REMARKS

In response to the Office Action mailed March 31, 2000, the cited reference has been reviewed and the rejections and objections made to the claims by the Examiner have been considered. The claims presently on file in the above-identified application are believed to be patentably distinguishable over the cited reference and, therefore, allowance of these claims is earnestly solicited.

FIG. 1

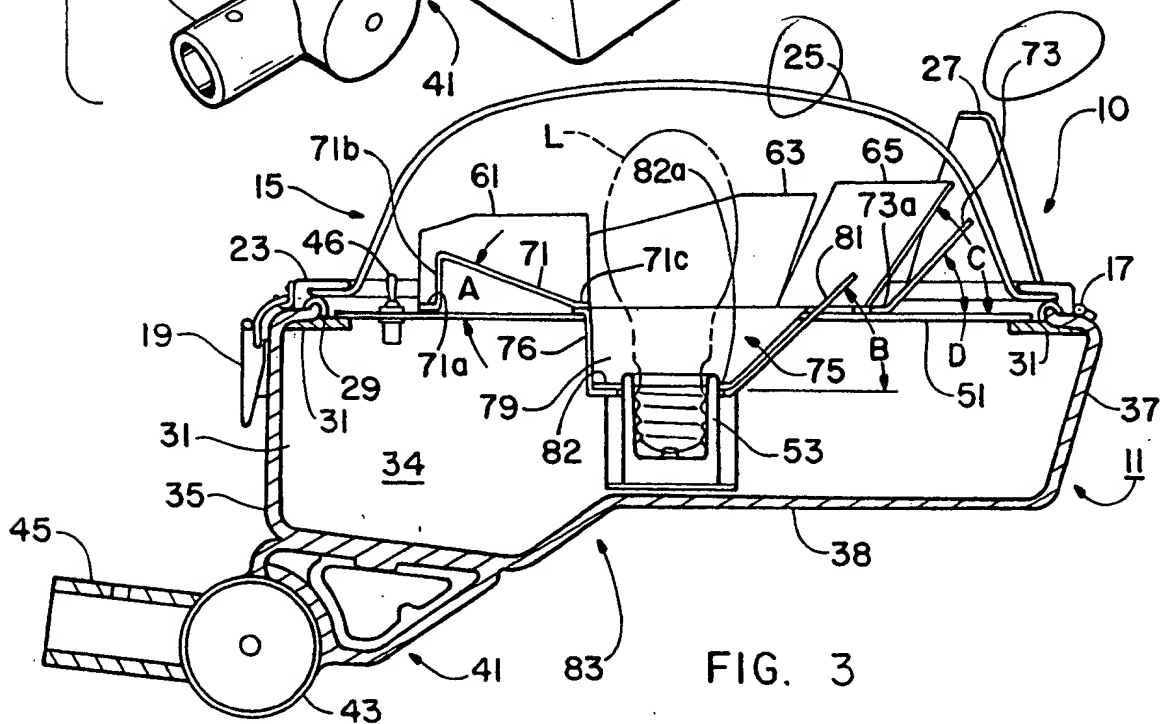
The Examiner has objected to the drawings under 37 CFR §1.83(a) on the ground that they fail to show elements 25 and 73 as described in the specification. The Applicants respectfully disagree. For the Examiner's convenience, enclosed herewith are copies of as filed FIGS. 1, 3 and 4 wherein these elements are encircled in red. No drawing correction is required.
